B	PROPOSED NORTH AND WEST ELEVATIONS AND PROPOSED GROUND AND FIRST FLOOR PLANS REVISED AS SHOWN. ISSUED TO LOCAL AUTHORITY FOR NON-MATERIAL AMENDMENT TO ALREADY GRANTED HOUSEHOLDER PLANNING PERMISSION	01.09.2017
A	ISSUED TO LOCAL AUTHORITY FOR HOUSEHOLDER PLANNING APPLICATION	21.06.2017
-	ISSUED TO LOCAL AUTHORITY FOR PRE-PLANNING ADVICE	05.05.2017
REV.	REVISION NOTES	DATE
CLIENT AND SITE ADDRESS Mr. & Mrs. P. LEWIS 'HILLCREST', 287 CANTERBURY ROAD DENSOLE KENT CT18 7BB		
PROJECT PROPOSED TWO STOREY SIDE/REAR EXTENSION, SINGLE STOREY REAR EXTENSION, AND DETACHED DOUBLE GARAGE		
DRAWING TITLE PLANS AND ELEVATIONS		
SHEET 1 OF 3		
SCALE	DATE	DRAWN BY
1:100 AT A1	FEBRUARY 2017	M.L.
DRAWING No.	REVISION	
2017/001/01	B

PROPOSED REAR ELEVATION - (WEST)

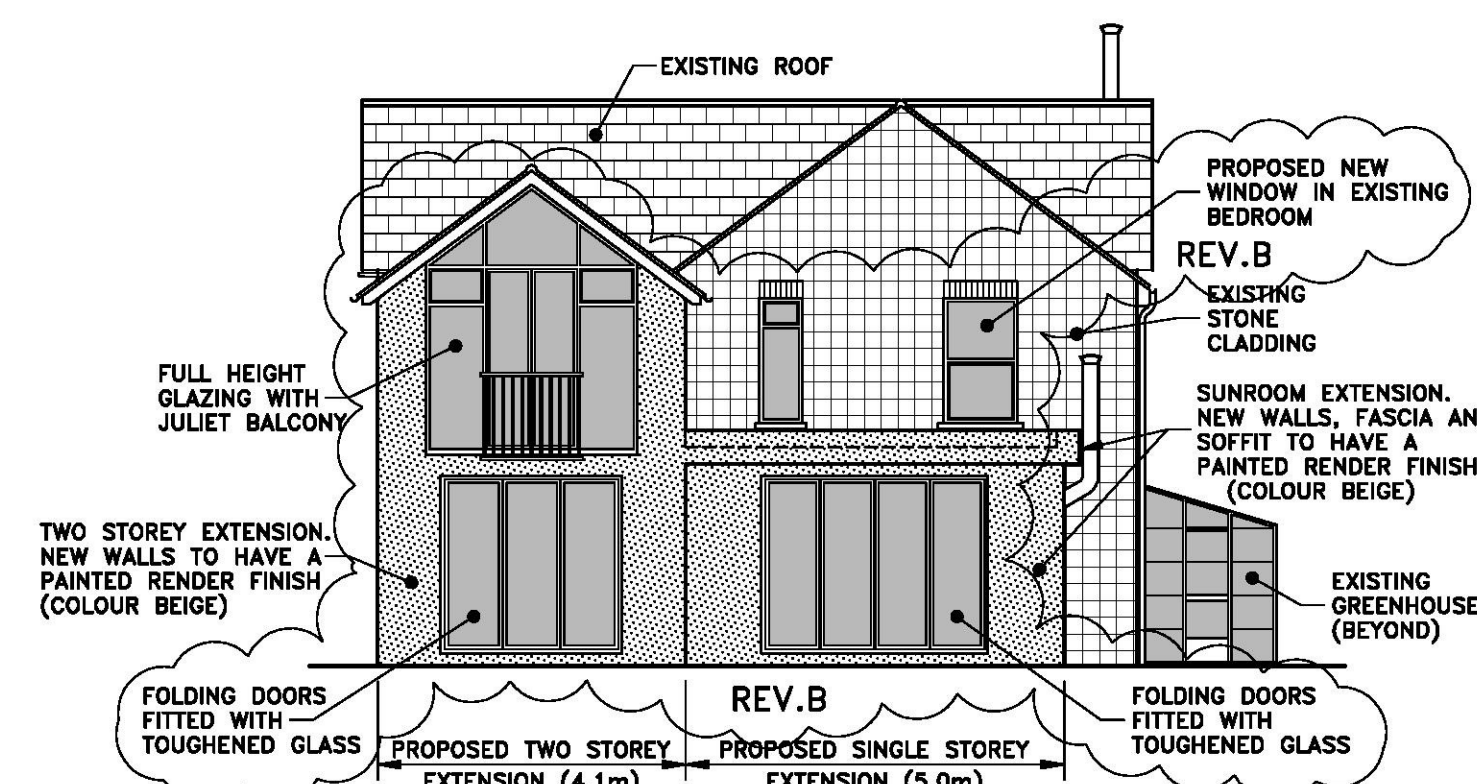
REVISION B
WEST ELEVATION
4. PANEL BI-FOLD SOLID OAK FRAMED DOUBLE GLAZED UNITS TO REPLACE PREVIOUSLY SPECIFIED WHITE UPVC UNITS TO PROPOSED SUN ROOM.
3. PANEL BI-FOLD SOLID OAK FRAMED DOUBLE GLAZED UNITS TO REPLACE PREVIOUSLY SPECIFIED WHITE FRAMED UPVC DOOR AND WINDOW TO PROPOSED MASTER BEDROOM NOW TO BE FORMED IN UPVC FRAMES - COLOUR OAK. EXISTING WHITE FRAMED UPVC BATHROOM WINDOW TO BE REPLACED WITH A NEW UNIT FORMED IN A UPVC FRAME - COLOUR OAK. A NEW WINDOW IN THE EXISTING SOUTH WEST BEDROOM IS TO BE FORMED IN A UPVC FRAME - COLOUR OAK.
NORTH ELEVATION
HALF GLAZED EXTERNAL DOOR WITH OBSCURE GLASS PREVIOUSLY SPECIFIED TO PROPOSED UTILITY ROOM TO NOW BE FULLY GLAZED IN A WHITE UPVC FRAME WITH OBSCURE FILM OVER GLASS.
